## CITY OF LODI

**AGENDA TITLE:** Review schematic design for Aquatics Facility project and authorize proceeding with construction documents phase

**MEMORANDUM, City of Lodi, Community Development Department**

**To:** Site Plan and Architectural Review Committee (SPARC)  
**From:** Community Development Department  
**Date:** September 9, 2002  
**Subject:** Review of the Aquatics Facility for the City of Lodi, located at 402 East Sargent Road.

## SITE PLAN

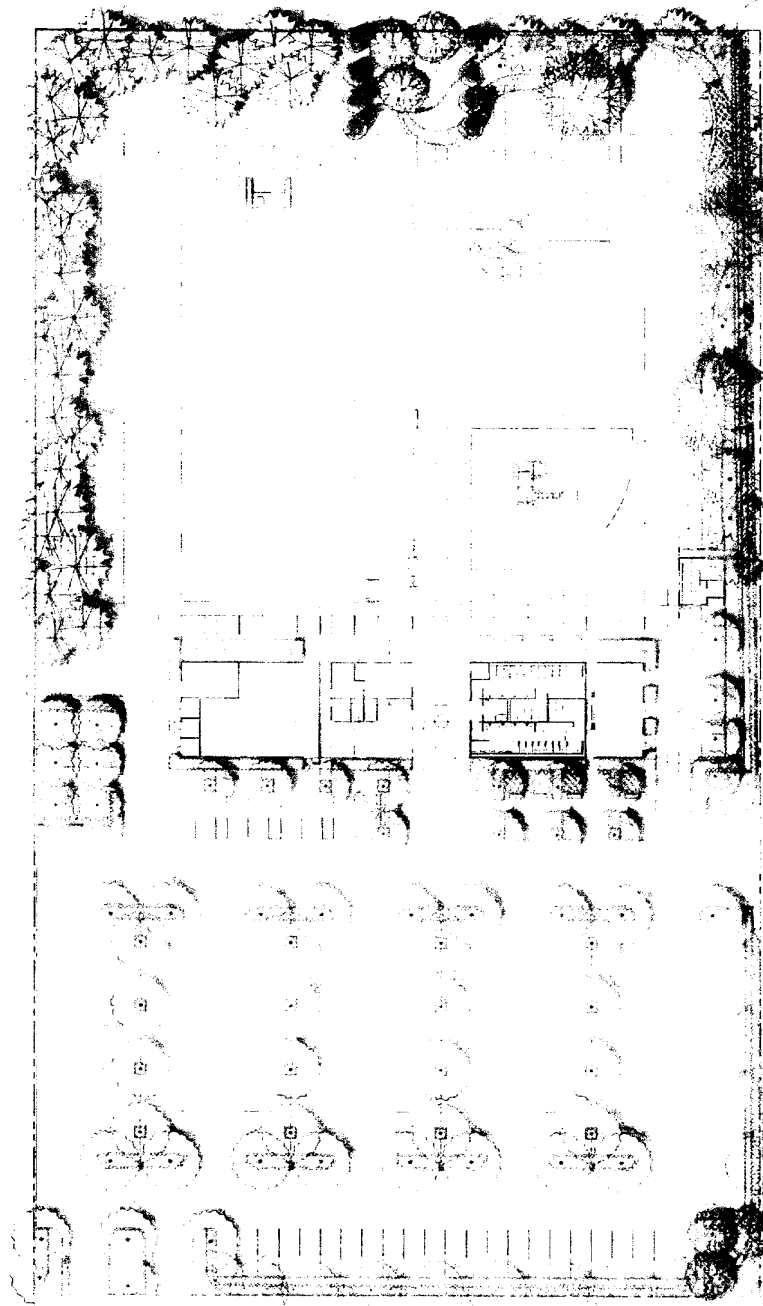
John Johnson, 106 Orange Avenue – Mr. Johnson asked what the depth of the pools are and is there something going to be submerged into the 50m pool to accommodate lessons. Commissioner Schuh stated this was brought up by John Griffin and it was decided this was something that could be added later.

Because the project is an Aquatics Center, the primary focus of the site is the location of the three separate pools. As stated earlier the Aquatics Center will serve two separate customer types, the first being recreational swimmers and the second being competitive. The recreational pools are grouped at the eastern half of the site near the picnic tables and the concession building, and closest to the restroom facilities. The 0-depth recreation pool

where small children will be most often is the closest to the restrooms and concession area. The 50-meter competition pool is separated from the recreational area by about 50-feet to the west, and is designed to be physically separated with a partition if necessary.

The pools are located on the north side of the building for two reasons. The first is that this location places the pools the farthest away from the future residences to the south across Vine Street. The second is that this location provides spectators with the friendliest orientation because they will be sitting in the shade of the building and the glare of the sun on the pool will be minimized.

While the building is the least important part of the project, it plays an integral role in the site design by physically and visually separating the parking area from the pool area. The building is essentially a long narrow shoebox shape spanning the width of the pool area.

The Parking lot location is at the south end of the site, because the location provides for the easiest access from Vine Street and "Road B," and more importantly will seamlessly connect with the parking lot of the future park site adjacent to the west. The 132 stall parking lot for the Aquatic Center and the future parking lot for the park will eventually become one.

Overall, staff is quite pleased with the resulting design and choice of materials. We also find that the site is laid out in an efficient and intelligently designed manner. The building connotes a high quality design that the citizens of Lodi can be proud of. As this is a City building, we will, of course, make sure that our standard comments are met. No further conditions are recommended.

Staff recommends approval of the City of Lodi Aquatic Center located at 420 East Sargent Road, subject to the standard checklist attached.
